## Reply on RC2

Author comment on "Improved representation of groundwater-dominated catchment using SWAT+gwflow and modifications to the gwflow module" by Estifanos Addisu Yimer et al., Hydrol. Earth Syst. Sci. Discuss., <https://doi.org/10.5194/hess-2022-169-AC2>, 2022

**Figure 1.** Daily hydrologic fluxes (mm/day) for watershed inputs (precipitation, boundary inflow; positive value) and watershed outputs (negative values), for the period 1993-1996.

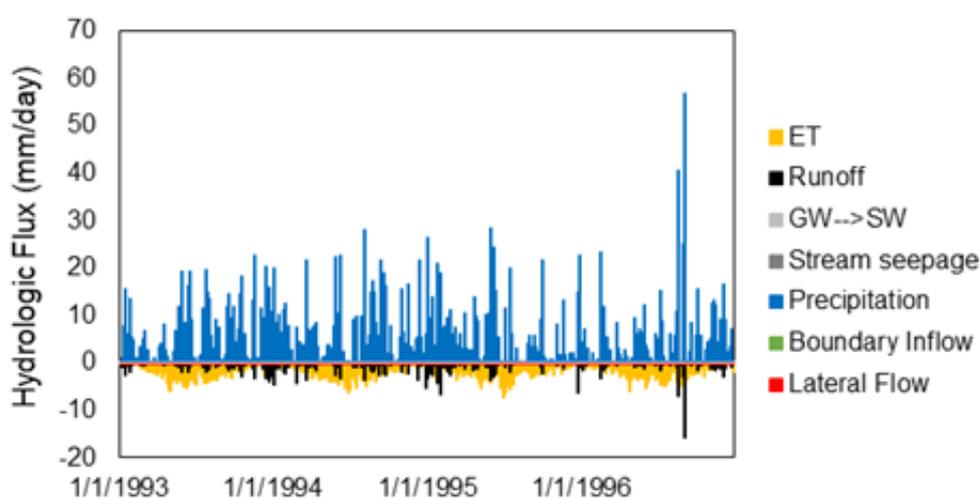
- *Again, the current analysis simply compared two modeling results in modeling streamflow and simply showed the modeled groundwater balance. A scientific analysis on why the SWAT+gflow model shows improvement in modeling streamflow (e.g., you can analyze the runoff components, the difference between two modeling results in water table depth, recharge) is needed.*

Daily hydrologic fluxes of watershed inputs and outputs (Figure 1) show seasonal patterns of ET, runoff, and soil lateral flow. The components of water yield (surface runoff, soil lateral flow, saturation excess flow) are shown in Figure 7A, with saturation excess flow being zero, due to the inclusion of the gwsoil term, and hence the groundwater head as simulated by the gwflow module not allowed to rise to the ground surface and induce saturation excess flow, but instead groundwater is incorporated into the soil profile and managed by the HRU soil processes of runoff and soil lateral flow. For this condition, therefore, soil lateral flow acts as a pathway for groundwater to reach the stream network, and hence can be considered as baseflow. This allows an accurate depiction of baseflow, as shown by the streamflow comparison in Figure 2A. The inclusion of the gwsoil mechanisms results in net recharge (Figure 2C) that, when averaged over the entire watershed, is usually positive, but can be negative as groundwater is transferred to the soil profile but no recharge occurs.
